C2PC permissive change letter

C2PC permissive change letter for certification of FCC ID: 2APMK-2601203T

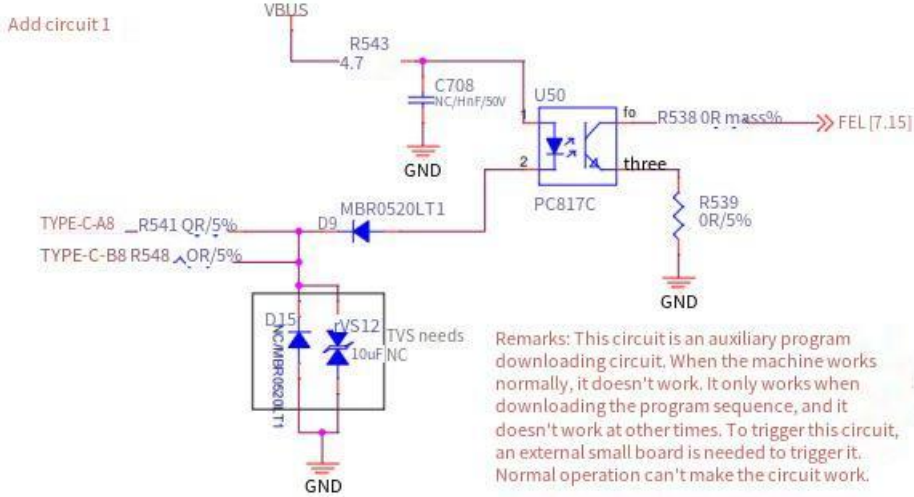
Requirement	Answers
No hardware changes have been made.	<p>The difference between the old version and the current version (V1.4) is that the following two circuits are added.</p> <p>Add part 1:</p> <p>Description of circuit function: This circuit is an auxiliary program downloading circuit. When the machine works normally, it doesn't work, only when downloading the program, and it doesn't work at other times. To trigger this circuit, an external small board is needed to trigger it. Normal operation can't make the circuit work.</p>  <p>Remarks: This circuit is an auxiliary program downloading circuit. When the machine works normally, it doesn't work. It only works when downloading the program sequence, and it doesn't work at other times. To trigger this circuit, an external small board is needed to trigger it. Normal operation can't make the circuit work.</p>

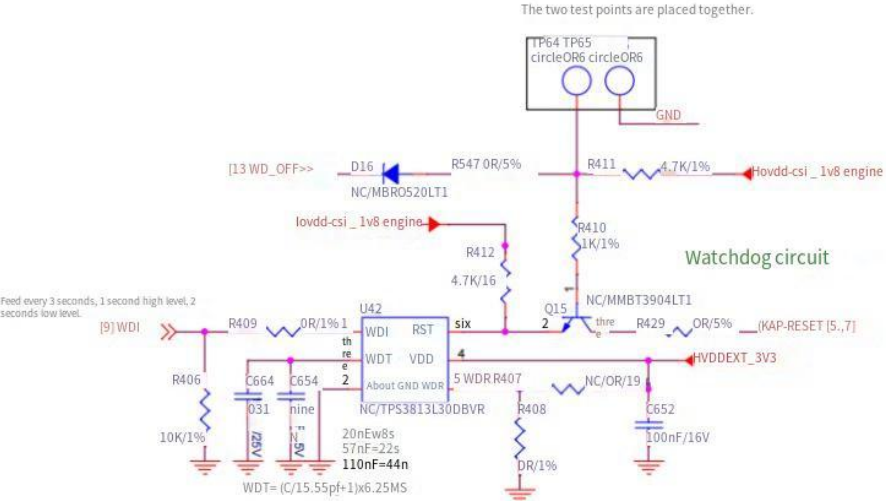
<p>Add part 2:</p> <p>This circuit is reserved, but not actually used, and the chip IC(U42) is not mounted. (This circuit is not used)</p> 
<p>There is no increase in the output power rating on new frequencies (unless such exceptions are permitted by rules or KDB publications – see V) G))</p>	<p>Yes, because the wireless circuit has not changed, the power is consistent with the original report.</p>
<p>The Equipment Class remains the same. (Changes that require a new Equipment Class code require a new grant of certification (FCC ID), except for SDR approvals.)</p>	<p>Equipment Class remains the same.</p>
<p>RF exposure changes must be addressed.</p>	<p>Yes, because the wireless circuit has not changed, the power is consistent with the original report.</p>
<p>Only the original equipment manufacturer may implement the new frequencies.</p>	<p>Equipment manufacturer no change.</p>
<p>There are no other changes to the device that indicate a need for a new FCC ID.</p>	<p>No other changes.</p>
